Drainage Report for Hunter's Ridge

REF: DRAINAGE PLAN FOR HUNTER'S RIDGE APARTMENT (L22-D38B)
RECEIVED OCTOBER 10, 1985

REF: DRAINAGE PLAN FOR HUNTER'S RIDGE APARTMENTS (L22-D33B) RECEIVED
OCTOBER 10, 1985

RE: DRAINAGE PLAN FOR HUNTER'S RIDGE APARTMENTS (L22-D33B) RECIEVED
AUGUST 9, 1985

8000 PROPELLER PUMPS
PUMP PERFORMANCE

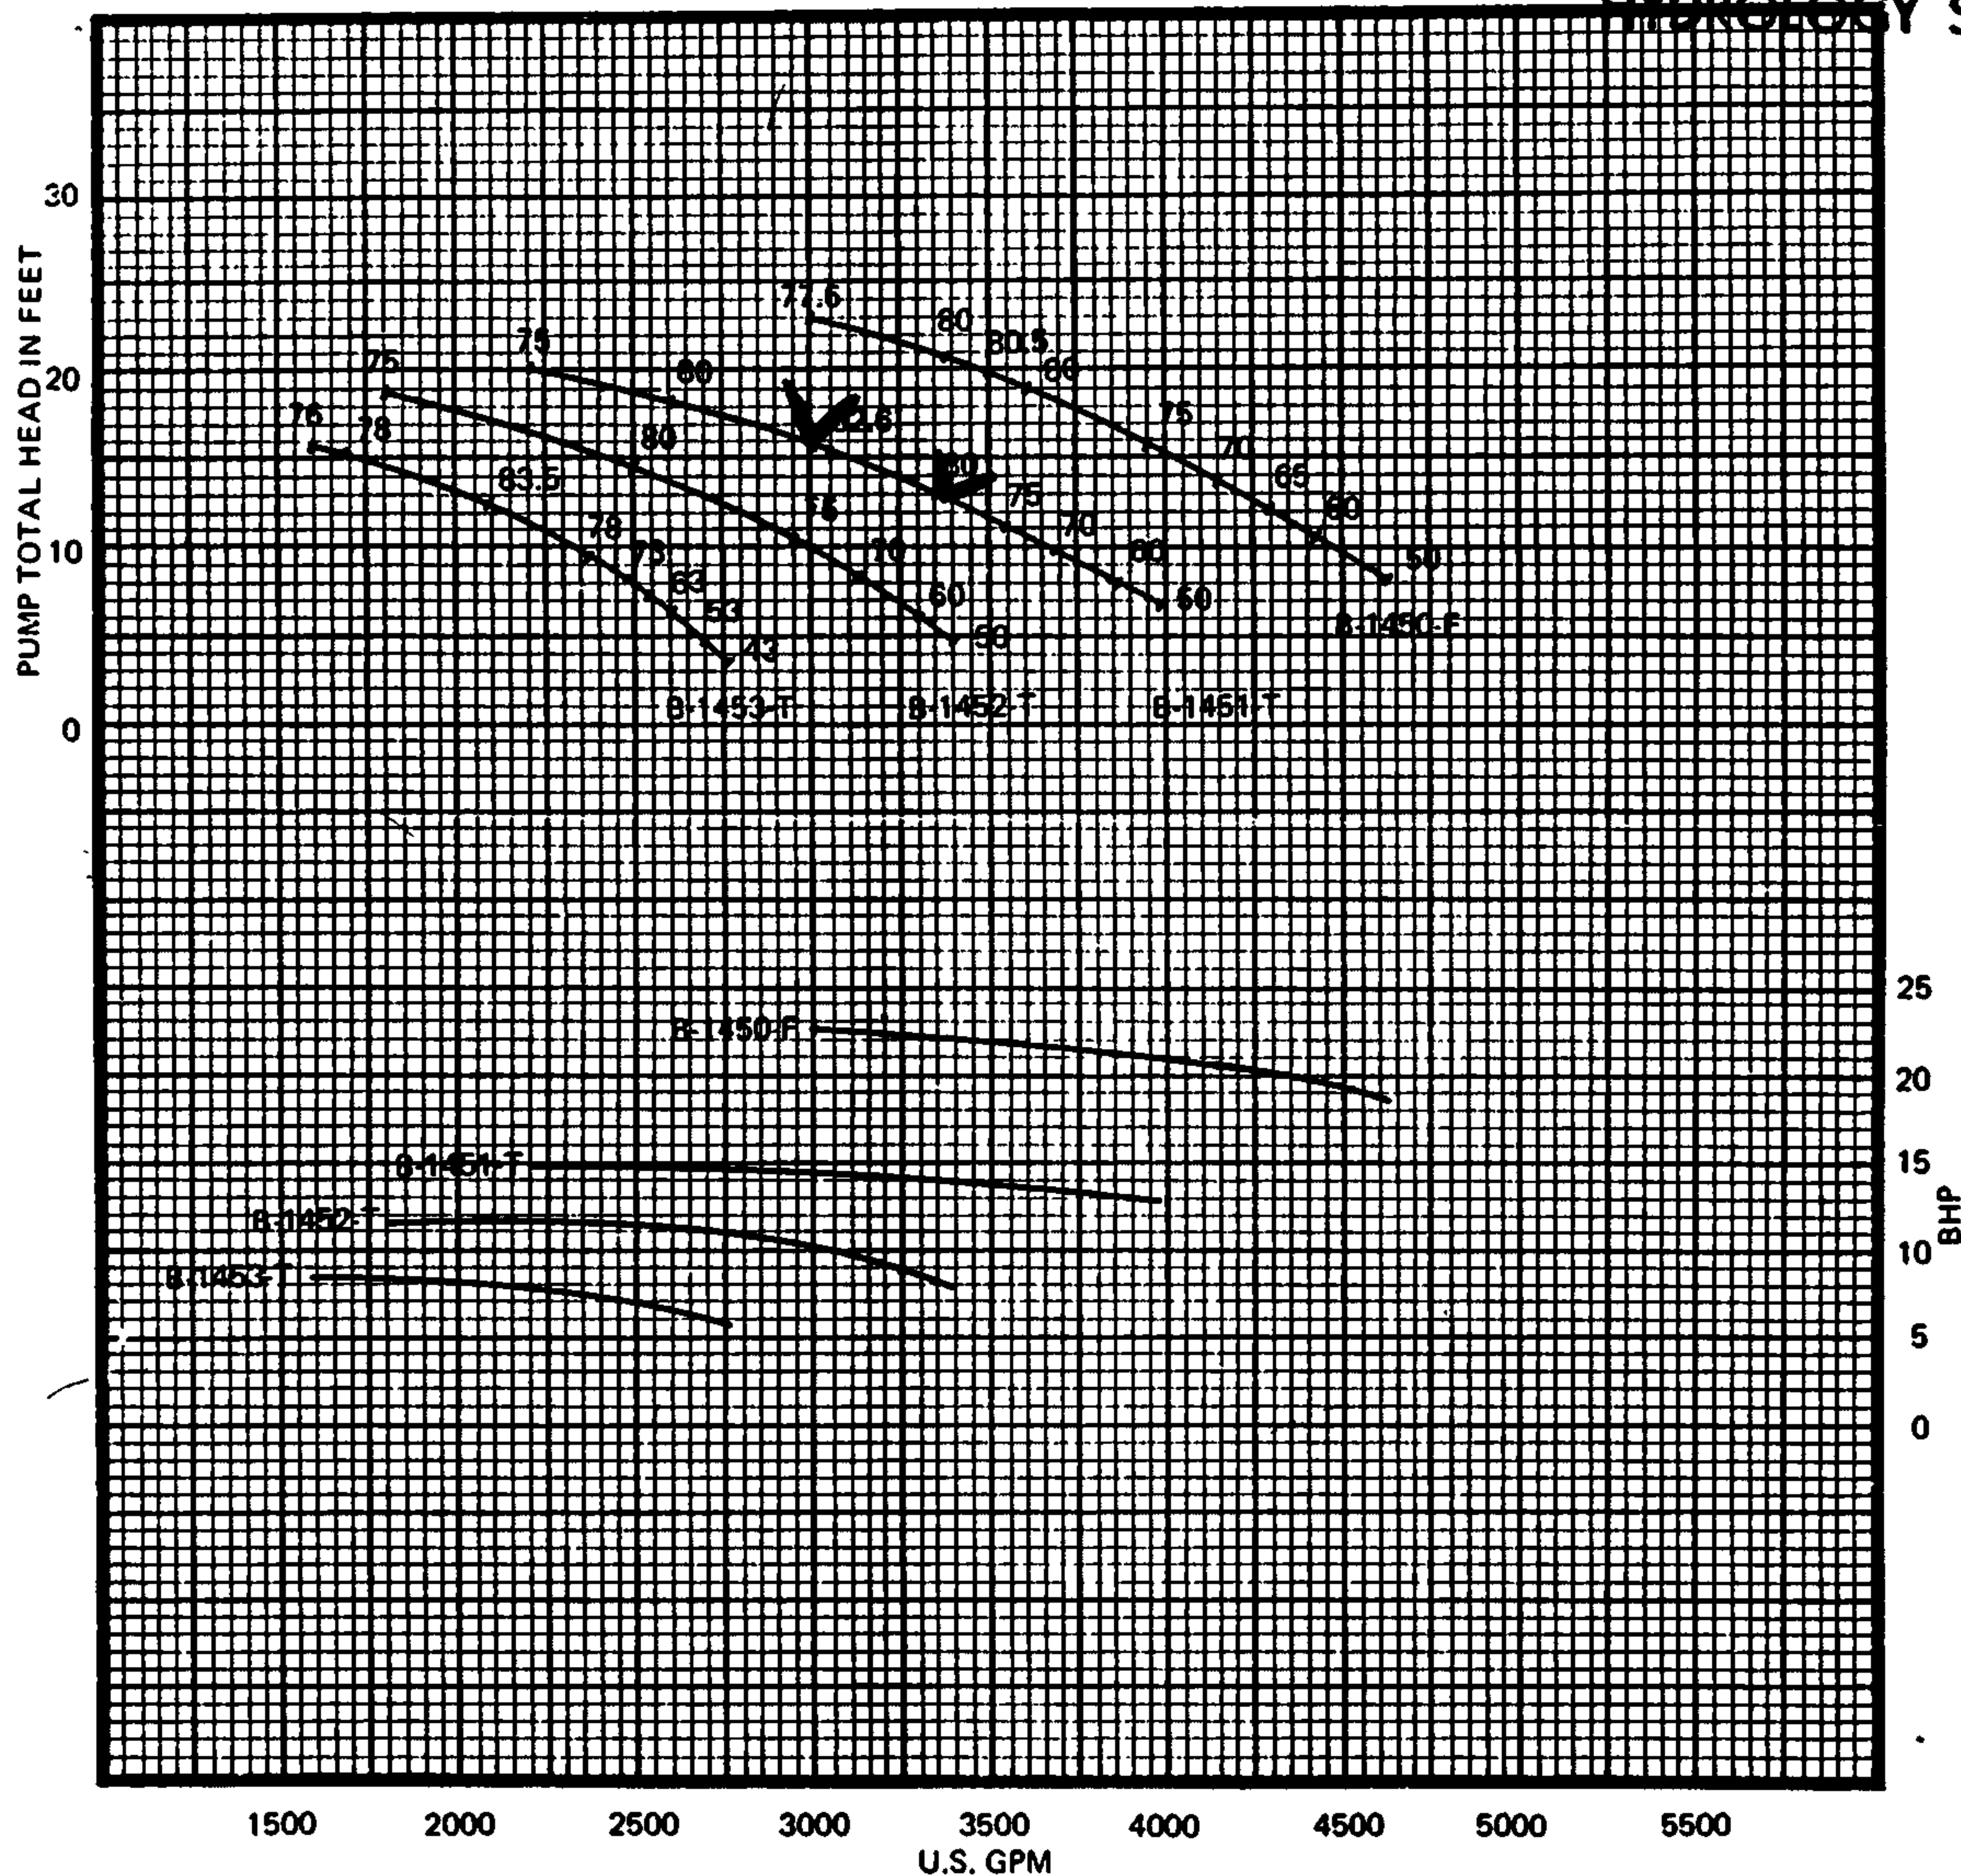
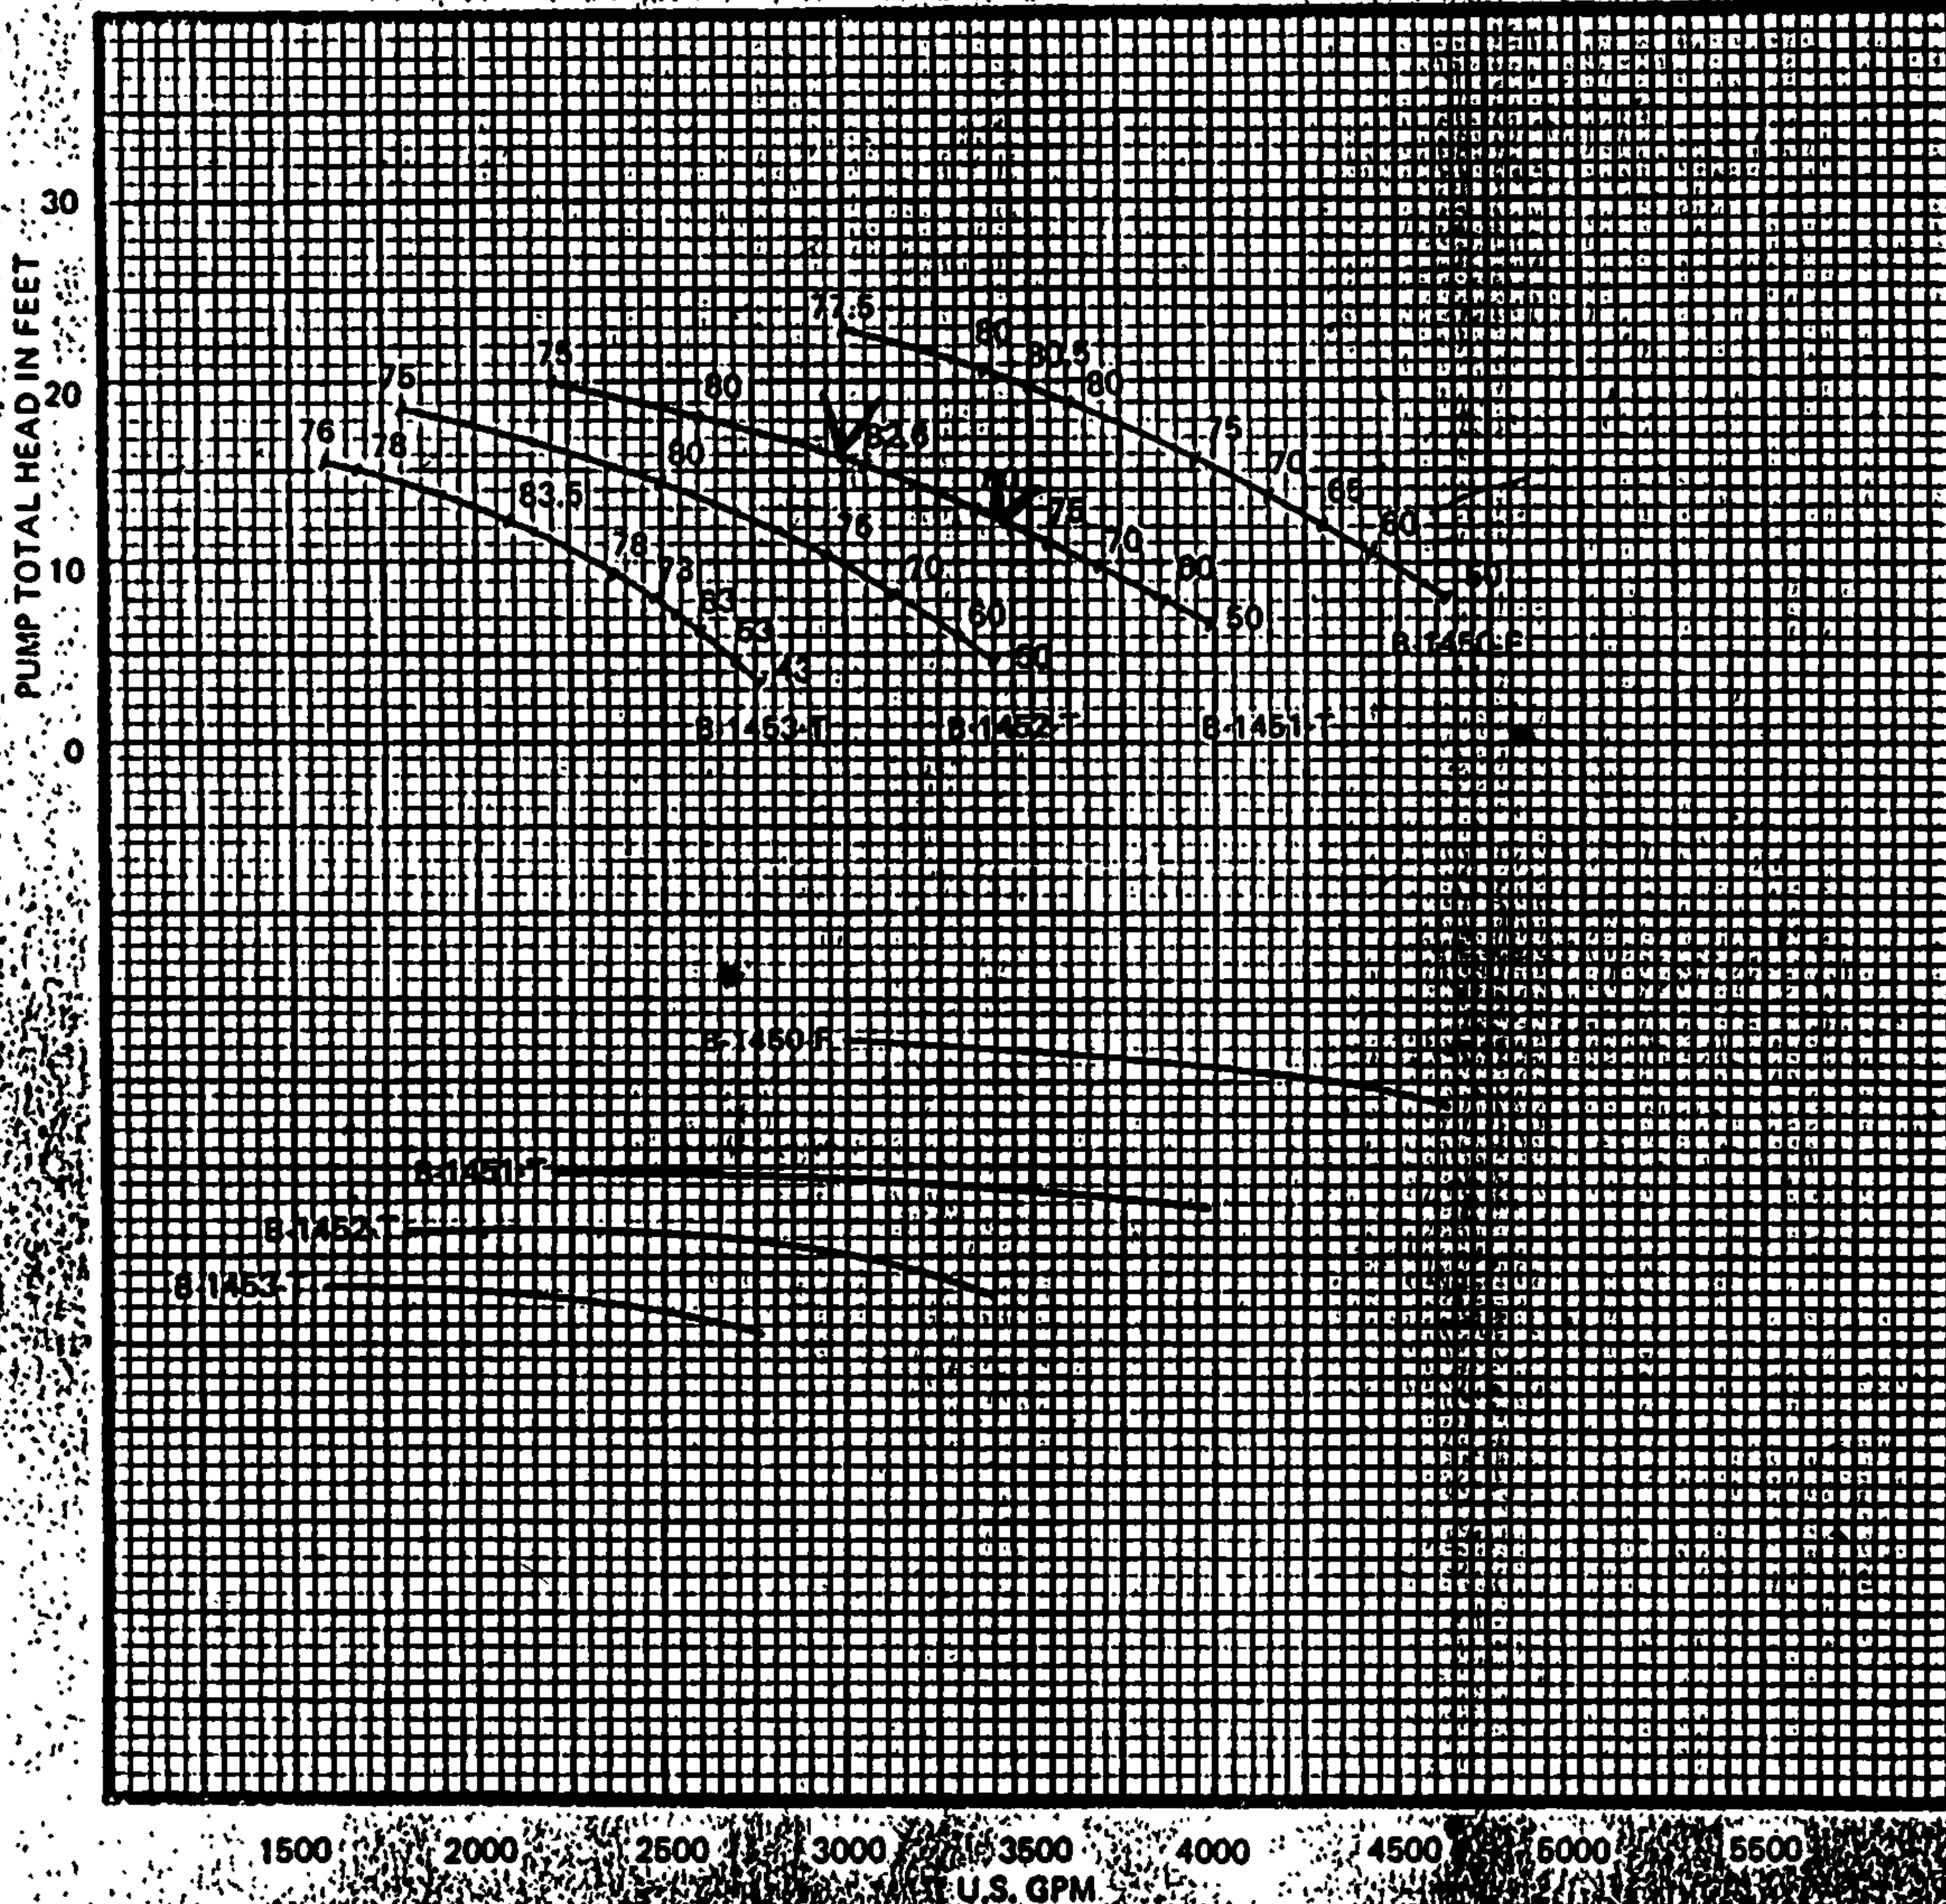
1. Please submit information curves or calculations showing the capacity of the pump.
2. Require City approved street grades for Wenonah Ave. adjacent to your site.
3. We require that a temporary Bench Mark be located close to the proposed site. Please submit its location and monumentation.
4. Please address the off-site flows from Tract F. Existing off-site flows must be conveyed through your site to the pond.
5. Please be advise that the completed concrete pond with working pump must be constructed prior to any CO being release for the individual buildings. This system is labeled as being your temporary erosion control plan.

1. Cut sheets from the pump catalog have been mailed to your office.
2. Top of curb and flowline grades shown on Sheet C-2 are exactly those shown on Sheet 6 of 10, Project No. 2459. This is the approved sheet by which Wenonah Avenue SE will be constructed.
3. Project bench mark will be the city brass cap shown on Sheet C-2. It is approximately 1 block from our site.
4. Offsite flows from Tract F will surface drain as sheet flow onto our property and will follow the same route as on-site flows. Preliminary design drawings of the Tramway Blvd. extension show flow from Tract F going to Tramway. Until Tramway is built, Tract F will contribute flow to our site as follows:
